# SERVICE AND APPLICATION NOTES

May 15, 2013  
C-13-05

## ECB29-12.5 and 15kw Electric Heat Sections Matched with CB29M-31 Air Handlers

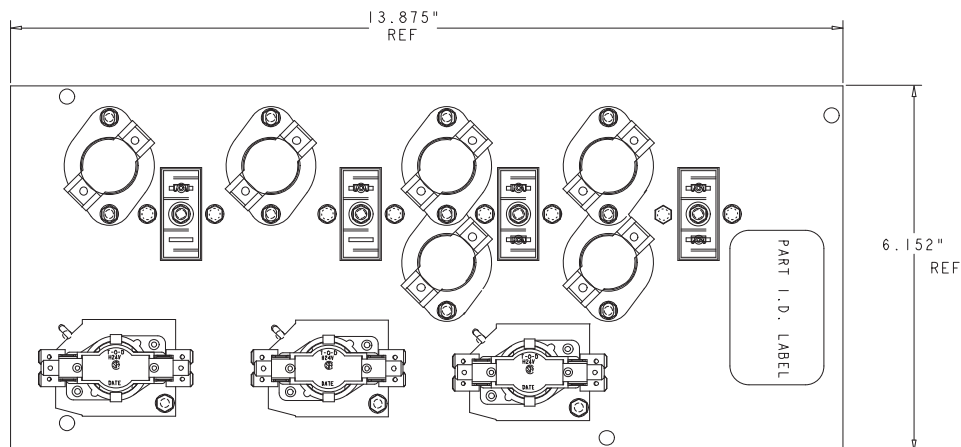
**Issue:** Field reports of replacement electric heat solutions not fitting in available opening.

**CB29M-31 electric heat section opening width is 10.56"**

**Mounting plate width is 13.875" on current ECB29-12.5 and 15kw electric heat sections**

**Solution:** Order replacement components (electric elements, sequencing relays, etc.) as needed, to repair the existing electric heat section. Electric heat sections currently being produced will not fit.
